<b>CITY OF WESTMINSTER</b>			
<b>PLANNING APPLICATIONS SUB COMMITTEE</b>	<b>Date</b> 28th January 2020	<b>Classification</b> For General Release	
<b>Report of</b> Director of Place Shaping and Town Planning		<b>Ward(s) involved</b> Hyde Park	
<b>Subject of Report</b>	<b>37 Gloucester Mews, London, W2 3HE</b>		
<b>Proposal</b>	Extension to rear courtyard at lower ground floor level, replacement of lower ground floor external windows and doors, internal alterations including conversion of vaults in association with lower ground floor flat		
<b>Agent</b>			
<b>On behalf of</b>	Dr Iain Bott		
<b>Registered Number</b>	19/08415/FULL and 19/08416/LBC	<b>Date amended/ completed</b>	08 January 2020
<b>Date Application Received</b>	29 October 2019		
<b>Historic Building Grade</b>	II		
<b>Conservation Area</b>	Bayswater

37 GLOUCESTER MEWS, W2 3HE  
 PERVID HOMES LIMITED  
 PROPOSED GLOUCESTER TERRACE  
 ELEVATION & SECTION D-D AND E-E

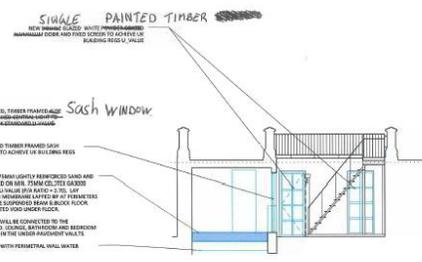
- Note that the building is listed to both its street sides, and that the Gloucester Terrace side has retained a high quality frontage though the poor quality of the lower ground floor level gives an opportunity for improvement back to the original form with sash windows introduced to the front bay.

- State that they strongly object to aluminium framed windows and doors, and for the rooflight to the extension, and that all new windows and doors should be timber framed and single glazed.

- State that double glazing is unacceptable for a listed building.
- Object to doors out from the vaults to the front lightwell and consider that the vaults should be solely lit by windows.

The application seeks to both replace the existing external windows and doors, and also to create new doors from the front vaults to the front lightwell. When initially submitted, the new windows and doors were largely proposed to be formed in aluminium and double glazed, and this attracted strong concerns from the SEBRA and the neighbour responder in terms of the impact on this listed building. Objections were also raised by SEBRA expressing a strong desire for the new windows to be designed to match the likely originals to the building and for them to be single glazed. Since that initial submission however, the application proposals have been amended and all the new external doors and windows are now proposed in white painted timber and are single glazed. To the front bay onto Gloucester Terrace the existing particularly unattractive casement windows are to be removed and replaced by a series of new sash windows in a style much more closely following the originals, which is notably welcomed in design

terms. The new entrance door and window to the southern end of the Gloucester Terrace lightwell also replace unattractive modern windows and doors in this location, and are also proposed in timber and of appropriate traditional design for the building. To the rear elevation, the new single glazed timber doors to rear lower ground floor level are in an appropriate design which will integrate successfully with the building, and replace an existing unattractive window. Whilst the panes of glass to the front bay sash windows and rear doors particularly will have a more horizontal emphasis, and though noting the concerns about the design of the windows in the objection letters, this arrangement is found to other windows in this building and others in the vicinity and as set out above is considered a notable improvement on the existing windows in place. The new windows and doors represent an improvement of the appearance of the building, and in their revised form are considered to overcome the concerns expressed by SEBRA and the neighbour responder.

Whilst it is noted that SEBRA object to the installation of doors in the wall between front lightwell and the front vaults, such vaults were typically originally constructed with access doors, and the principle of doors in this location is therefore considered acceptable. The design of the doors is considered sympathetic to the character of the building, and they are to be formed in glazing and white painted timber framing.

- 5 The new sash windows to the front elevation at lower ground floor level shall operate only in a vertically sliding manner

- 8 You must apply to us for approval of detailed drawings of the new external windows and doors including details of glazing bars. You must not start any work on these parts of the development until we have approved what you have sent us.

- 11 You are advised that the details required for condition 8 should show the new windows and doors with traditional mouldings and glazing bar details
